Accessibility Evaluation

Monroe County Polling Location

**Stinesville Lions Club
8060 N Stinesville Rd
Gosport, IN 47433**

Report Date: 04/07/2026

Finding: 3

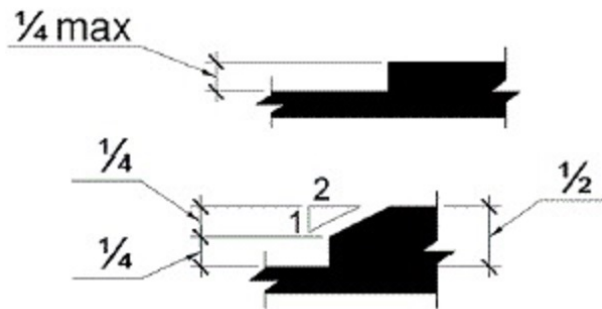
The threshold is greater than 1/2 inch high.

The threshold at a doorway shall be no higher than 1/2 inch. Changes in level between 1/4 inch and 1/2 inch must be beveled at 1:2 or less. 1/4 inch is the maximum vertical rise.

Recommend adding a temporary or permanent threshold reducer.

Finding: 4

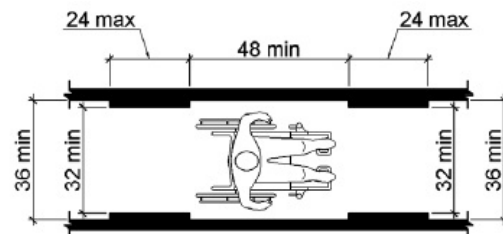
The route of travel from the rightmost access aisle does not provide the required minimum width.

The minimum clear width for sidewalks and walks is 36 inches.

However, clear width shall be permitted to be reduced to 32 inches minimum for a length of 24 inches maximum provided that reduced width segments are separated by segments that are 48 inches long minimum and 36 inches wide minimum.

Recommend trimming back the bushes.

Finding: 5

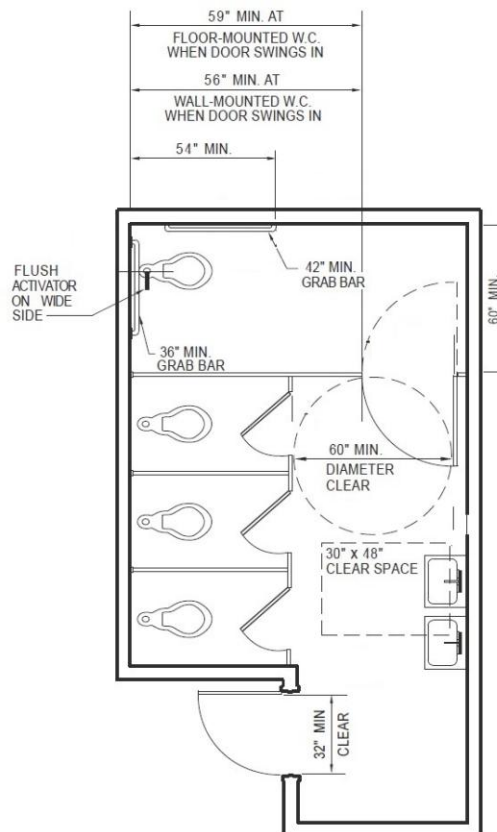
The restrooms are not compliant. Both lack rear grab rails, knee clearance at the sinks, and levers for the sinks. Door widths is only 30".

No feasible way to make either restroom compliant. Recommend adding signage indicating a lack of accessible restrooms and directing voters with disabilities to the front of the line. Alternatively, recommend placing an accessible portable restroom in the parking lot.
